QUINEBAUG VALLEY MIDDLE COLLEGE HIGH SCHOOL
742 UPPER MAPLE STREET
DANIELSON, CONNECTICUT
DCS PROJECT: BI-CTC-439
SDE PROJECT NO 584-0001N

BID OPENING	1:00 P.M.	November 22, 2011
ADDENDUM NUMBER #1	DATE OF ADDENDUM	November 10, 2011

5 FOUNDATION SECTION
 S2.04 3/4" = 1'-0"

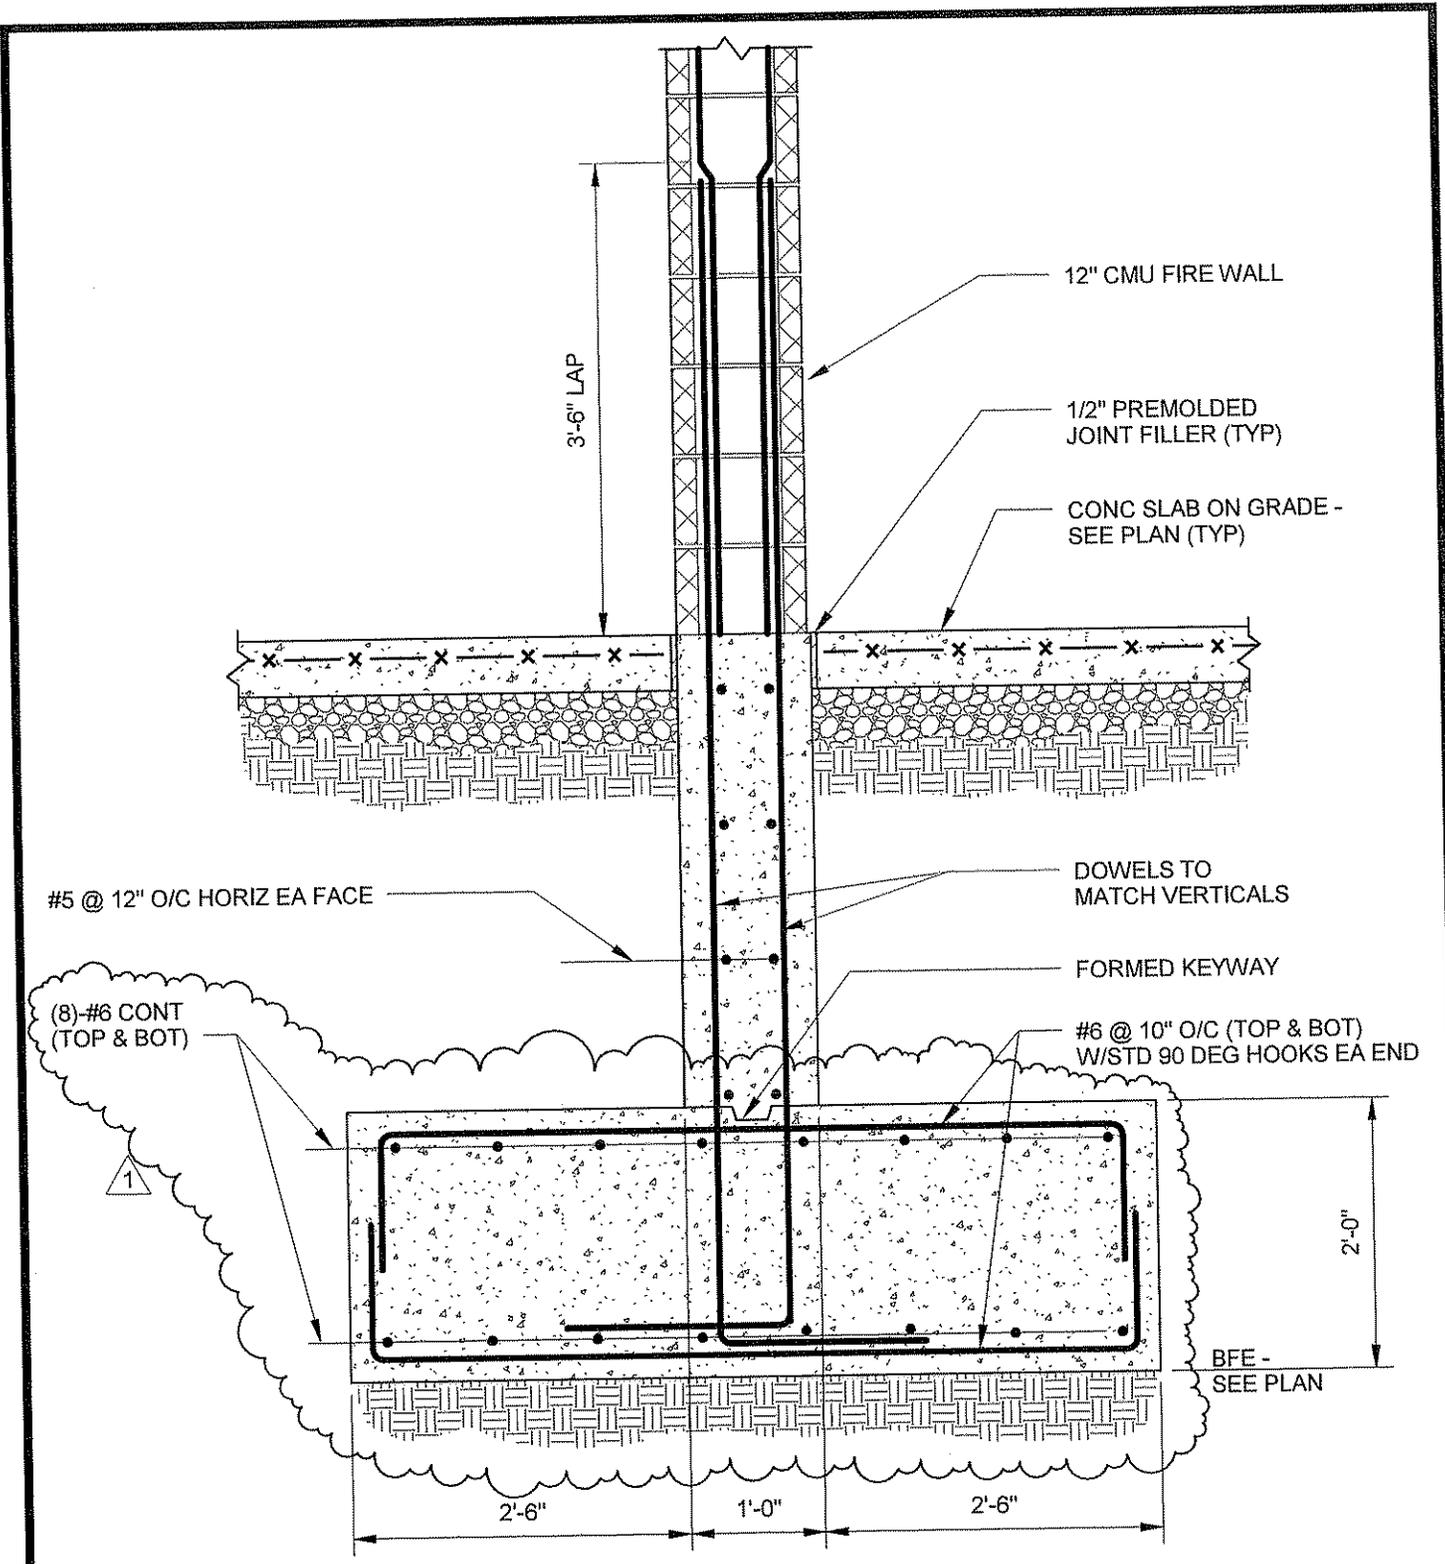
- Item 84
Sheet S1.07 – DELETE HSS10x8x5/8 (LSH) spanning between columns B1-8.9 and B1-10.
- Item 85
Sheet S2.04 – REVISE detail 5 as shown on attached sketch ADD1-S2.
